RE: Amendment Application for the Zonnequa Wind Farm (DEA ref.: 14/12/16/3/3/1/1970)

Genesis Zonnequa Wind (Pty) Ltd received Environmental Authorisation on 18 February 2019 for the Zonnequa Wind Farm and is proposing to amend the turbine specifications and layout of the Zonnequa Wind Farm. As part of the Amendment Application, Savannah Environmental has requested comment from 3Foxes Biodiversity Solutions on the ecological implications of the proposed changes to the layout and turbine specifications that would be included in the Amendment.

The amended layout of the Zonnequa Wind Farm, showing the 35 turbine layout proposed as part of the amendment.

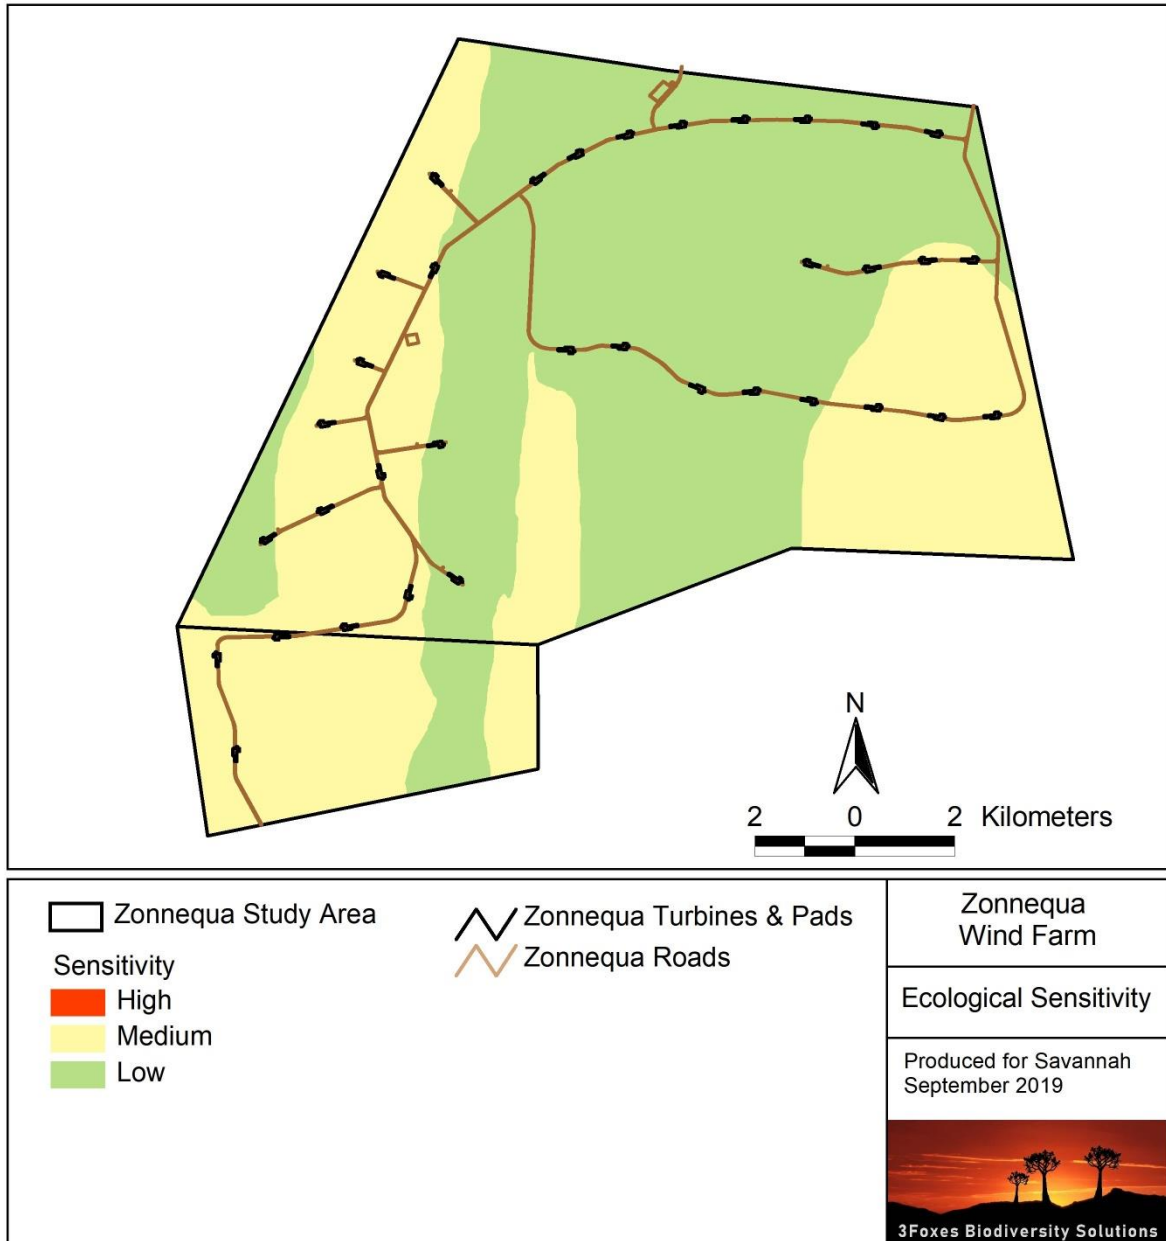
I have reviewed the proposed amended layout in reference to both the original assessed layout (containing 56 wind turbines) as well as the ecological sensitivity of the site. The ecological impact of the proposed 35 turbine layout is likely to be somewhat lower than the original 56 turbine layout as a result of the reduced number of turbines and access road footprints. No new impacts are expected to occur with the implementation of the amended layout. The amended layout is illustrated below in reference to the ecological sensitivity of the site. The total footprint of the facility would be reduced but this is not

considered sufficient to change the overall ecological impact of the amended layout as compared to the original layout. The larger turbine size is not considered to be of consequence with regards to terrestrial impacts as, while the turbine hard stand may be larger for each turbine, the reduction in the number of turbines would compensate for any increase in footprint associated with each turbine. In terms of flora, the construction phase impact resulting from the transformation of intact habitat associated with the development was assessed as being of medium significance after mitigation. Although the footprint of the development would be reduced under the amendment, this is not considered sufficient to reduce the overall post-mitigation impact on flora from Medium significance to Low significance. As such, the amendment is considered to have a positive impact on flora as compared to the original layout, but this benefit is not considered to be of sufficient magnitude to warrant a reduction in the assessed impact from medium to low and as such remains unchanged. In terms of fauna, the reduced number of turbines would mean that the average distance between turbines is larger with the result that faunal disturbance from the turbines or maintenance activities on the wind farm during operation would potentially be slightly lower. However, taking a conservative approach in this regard, this is not deemed sufficient to warrant adjustment of the assessed impacts on fauna downward as these were already assessed as being of low significance and consequently, there would be no overall change in the assessed impact on fauna.
